ECE/TRANS/WP.29/GRSG/2008/15  
11 April 2008

Regulation No. 43  
(Safety glazing)

Proposal for Supplement 11 to Regulation No. 43

Laminated glass panes other than windscreens having a regular light transmittance > 70 per cent

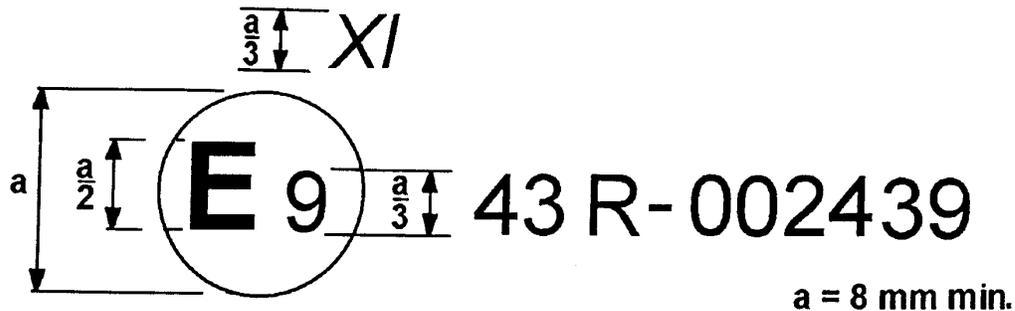
Annex 2, add the following approval mark example:

The above approval mark affixed to a laminated glass pane other than a windscreen, shows that the component concerned has been approved in Spain (E 9) pursuant to Regulation No. 43 under approval No. 002439. The approval number indicates that the approval was granted in accordance with the requirements of Regulation No. 43.
